FINAL ENVIRONMENTAL IMPACT STATEMENT

**NORTH SEATTLE COMMUNITY COLLEGE
MAJOR INSTITUTION MASTER PLAN**

August 20, 1993

This Chapter contains copies of the comment letters on the Draft EIS. Following each letter are the responses to comments made in that letter. Responses are keyed in the margins of the letters. A total of 25 letters were received. The letters are numbered and responded to in the following order.

Figure 3
Proposed Site Plan

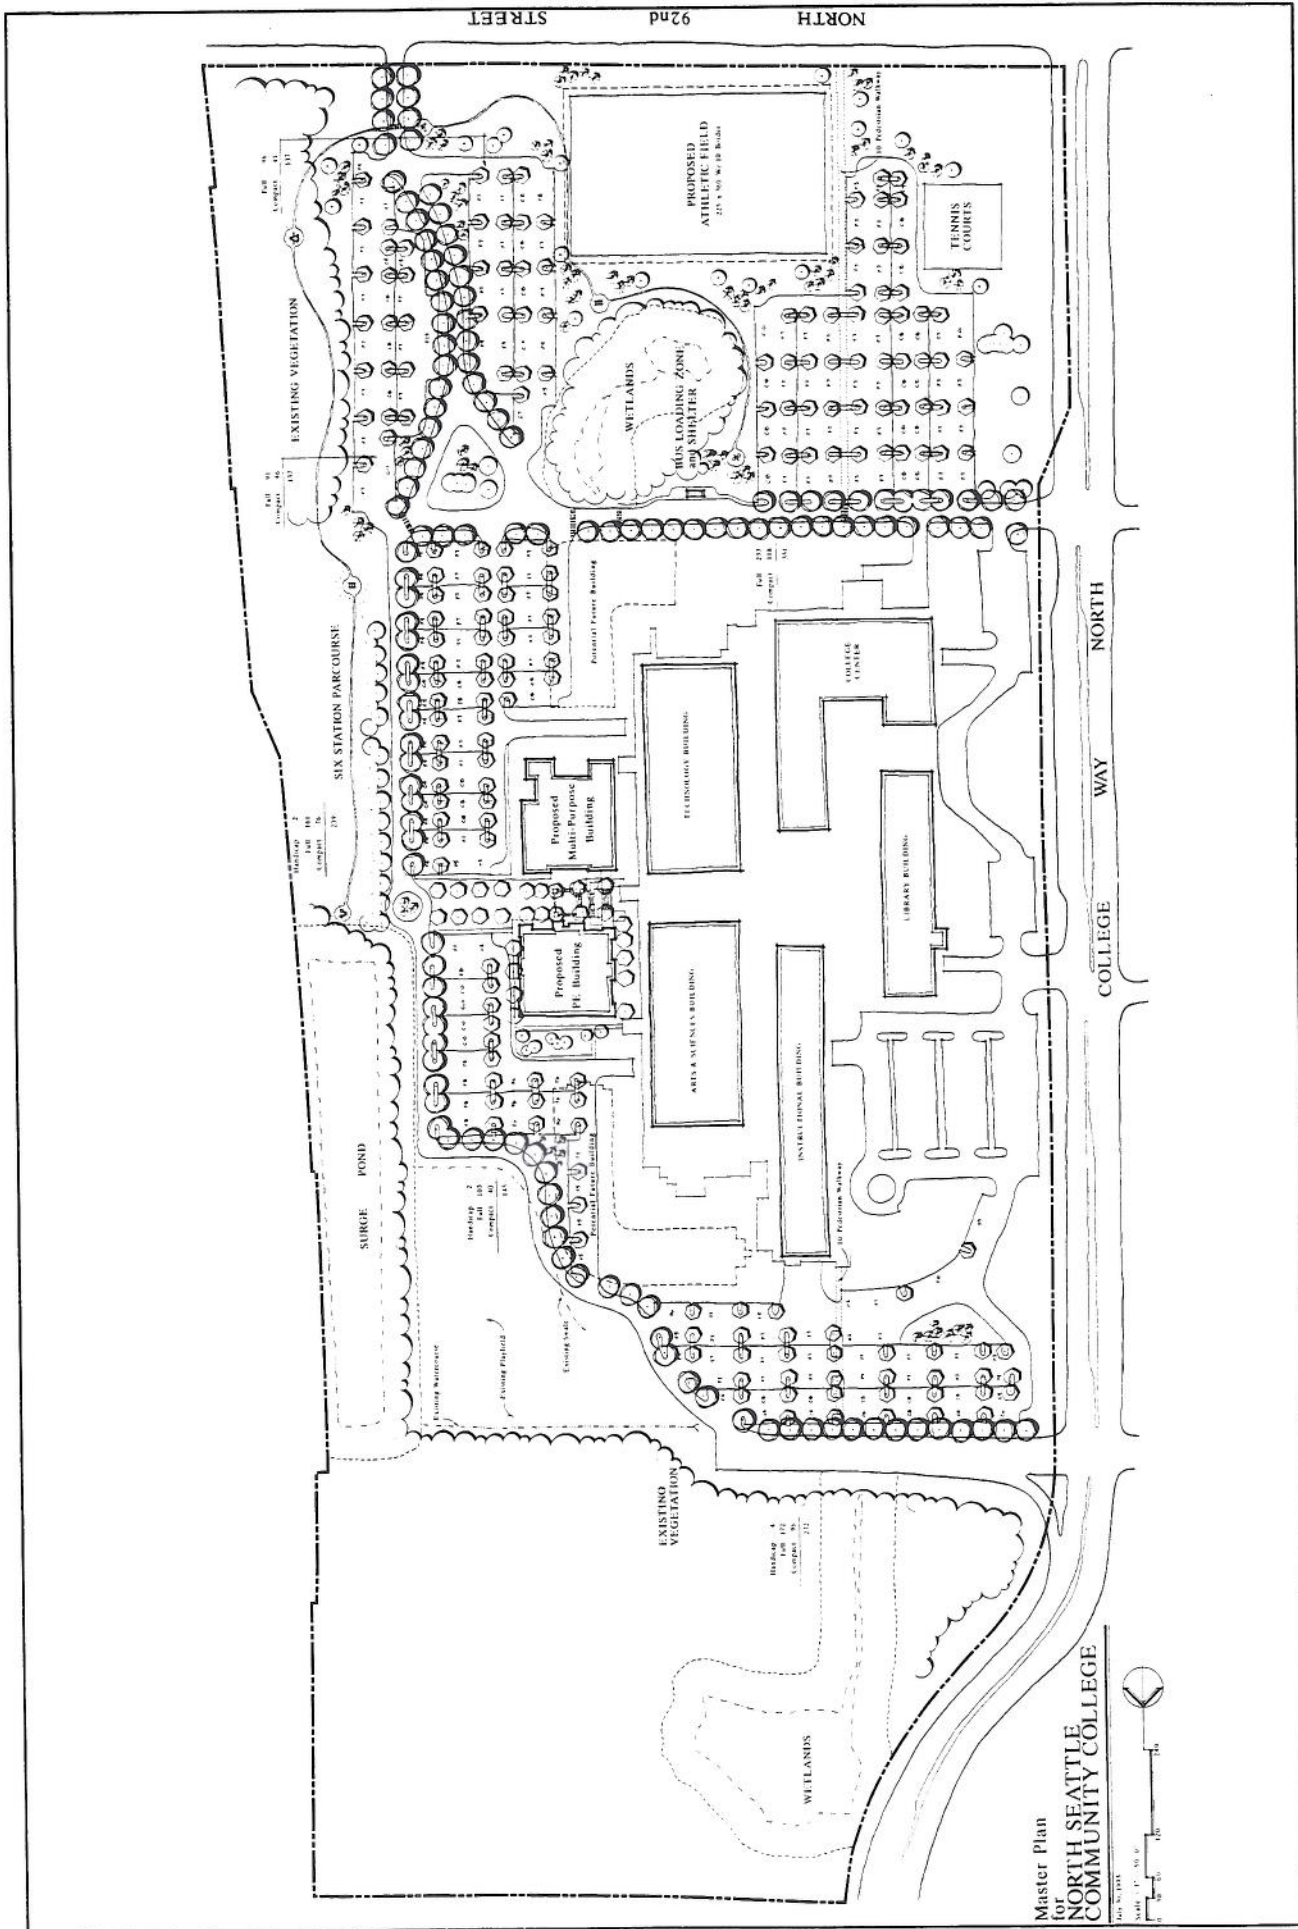
Figures 3 and 4 contain unreadable lettering. Please
provide replacement figures.

1. Comment acknowledged. Figures 3 and 4 have been revised and are provided in Chapter 1 (pages 1-5 and 1-9) of this document.
2. Based on a meeting with the Seattle Engineering Department and the Department of Construction and Land Use on November 25, 1992 (meeting minutes in Appendix D), it was concluded that it would be premature to provide detailed stormwater piping diagrams and analysis at the EIS stage of the project. The Additions and Errata Section (p. 3-4) of this Final EIS describes the general means by which detention will be provided in each phase.
